# Planning Report

## Avondale Woods – Concept Plan

Agenda Item	2
Case Number	10-036CP
Request	Review of a concept plan under the provisions of Code Section 153.050. The Planning and Zoning Commission provides non-binding feedback regarding the proposal, which may also be reviewed by City Council. A rezoning/preliminary development plan to establish a Planned Unit Development District may follow the concept plan review.
Proposal	The applicant, Homewood Corporation, is requesting review of a concept plan for a 120-acre site zoned R, Rural District. The proposal includes single-family homes, multiple family rental and condominium residential units, and over 37 acres of open space and preserved wood lots.
Site Location	5215 Avery Road Southwest portion of Dublin, located on the west side of Avery Road approximately 4,000 feet south of Rings Road.
Applicant	Jim Lipnos, Homewood Corporation.
Representative	Christopher Cline, Blaugrund & Herbert Incorporated.

#### North-South Connector Road

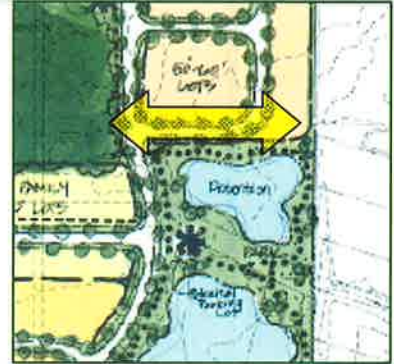
While the site's internal road network is intended to be walkable and pedestrian-oriented, the plan currently shows a long, fairly straight stretch of road through the eastern portion of the site. As such, it may be prone to higher traffic speeds. A more indirect street design may be necessary to slow traffic to properly integrate the parks/open spaces and pedestrian crossings. One alternative is to provide on-street parking with "bump-outs" to enhance the pedestrian-oriented design of this road.

# Proposed Concept Plan

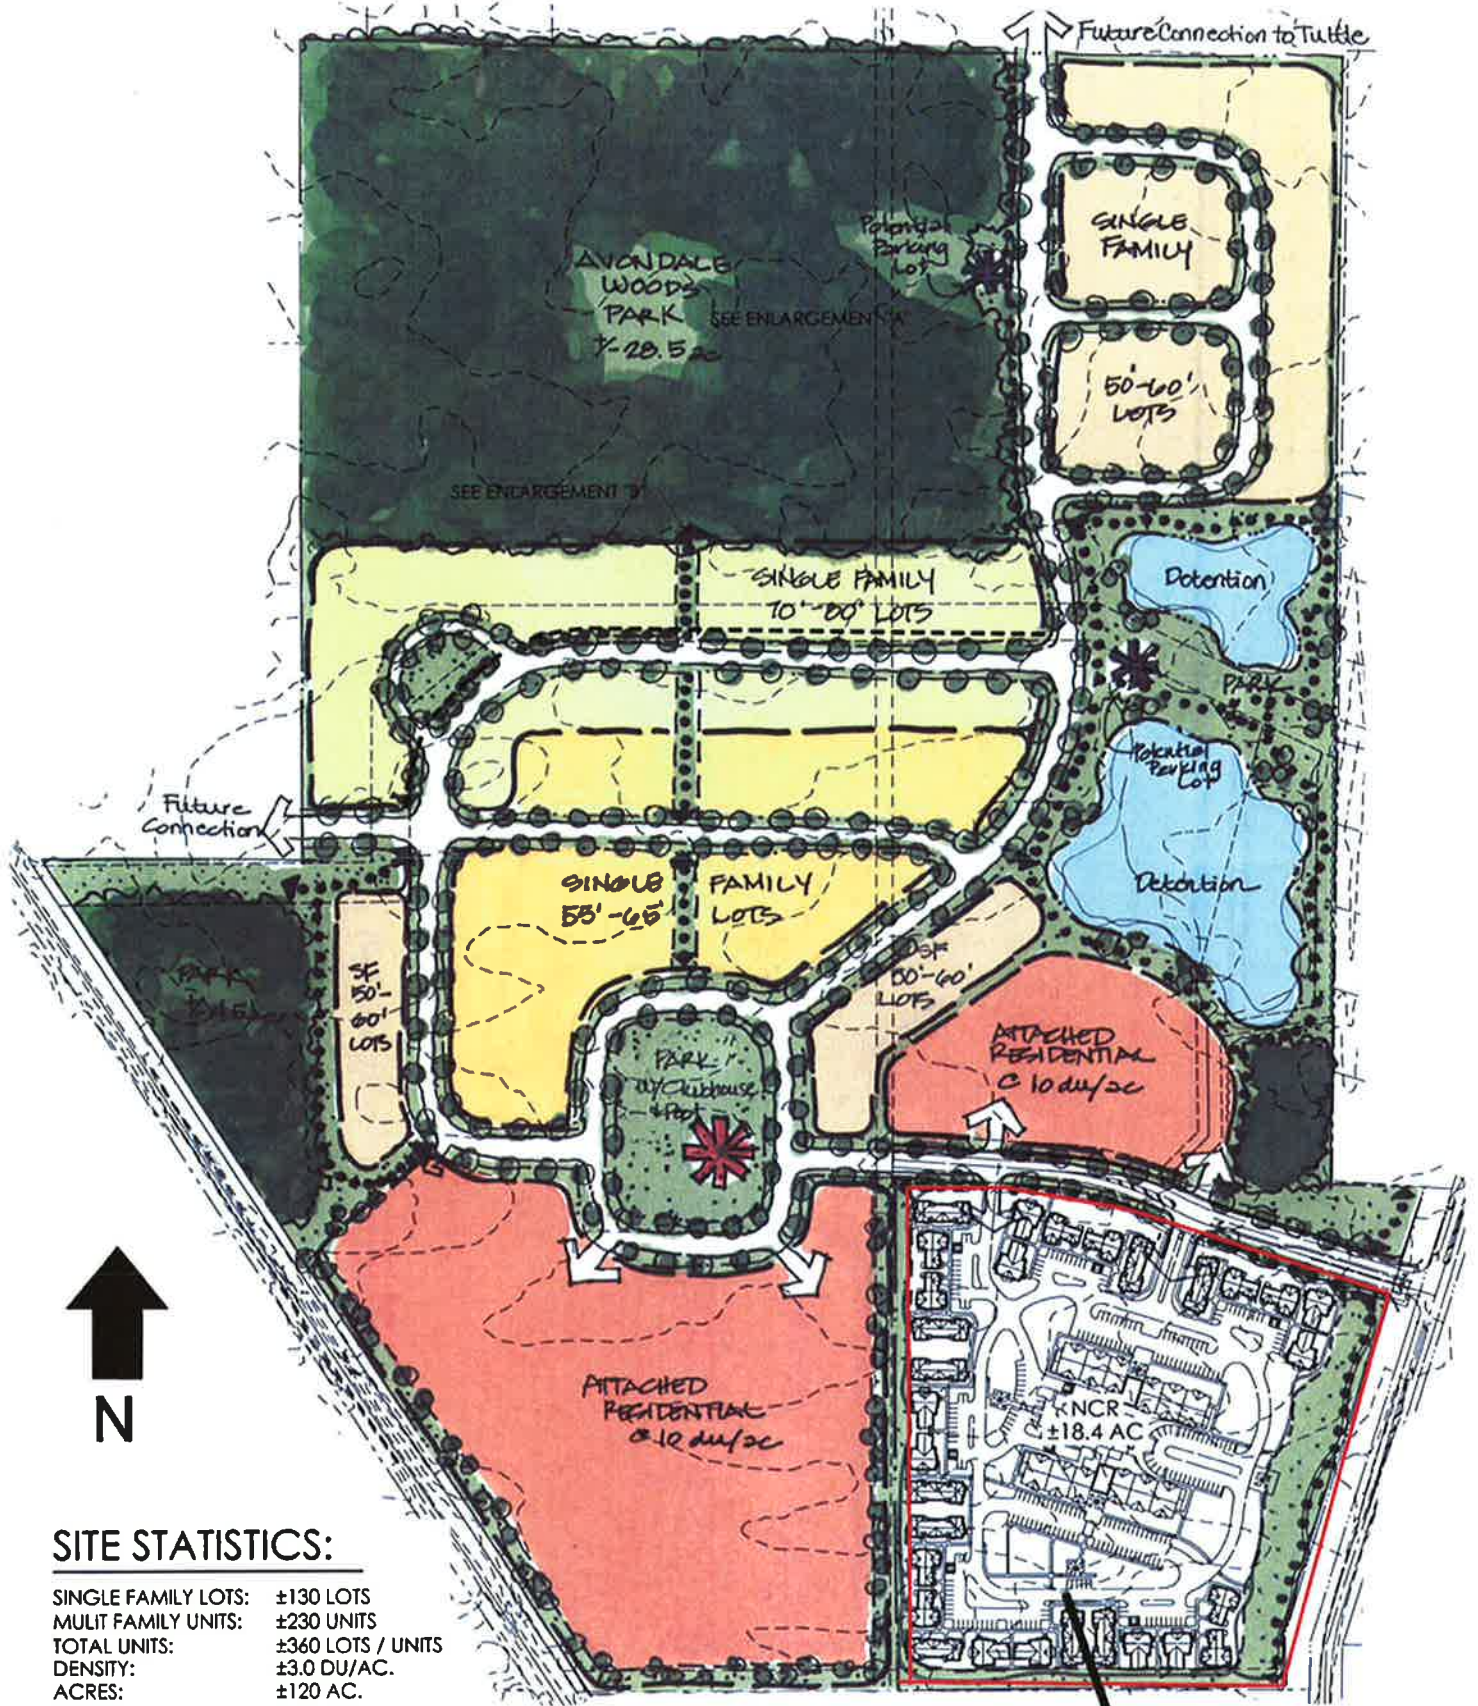
Bikepaths are shown throughout the site connecting each housing subarea within the neighborhood with the open space and park system. A bikepath is shown midway through the site connecting the Avondale Woods with the central green space. While the bikepath connection passing through the single-family portion of the site will help tie the neighborhood together, these mid-block street crossings may be unsafe for bicyclists and pedestrians. The applicant should consider an alternative arrangement, potentially creating an additional north-south street in this portion of the site.

A bikepath is shown passing along the front of the single-family lots on the south side of Avondale Woods. The applicant may want to consider relocating the bikepath to the rear of these lots like the bikepath shown along the rear of the lots backing up to the Triangle Woods to increase pedestrian and bicycle access to the potential Avondale Woods park.

One element of this will be the architectural character and street presence of the units around the green. The plan surrounds the central green by a roadway, with facing dwelling units, single-family on the north and multiple-family on the south. To provide a strong street character, units fronting the central green should be free of sidewalk and yard interruptions by driveways.

The Thoroughfare Plan includes an extension of Tuttle Crossing Boulevard from Avery Road to Cosgray Road but is not in the current five-year Capital Improvements Program (and has not been proposed in the CIP currently under review). The segment of Tuttle Crossing Boulevard north of this site is planned as a four-lane divided roadway with a 100-foot right-of-way. The precise alignment of this roadway is unknown. The alignment may provide some ability to place open space between the roadway and this development, however this cannot be assured and buffering will be needed to provide an adequate transition for the homes proposed along the northern boundary of the development.

A stub road is provided in the western portion of the site to allow future connection to Rings Road in accordance with the concept depicted in the Southwest Area Plan. Although this connector roadway may not be in place for some time, it is necessary to ensure this connection so that future residents are made aware of its development. The design of the internal street network will help minimize the potential for cut-through traffic through the site.
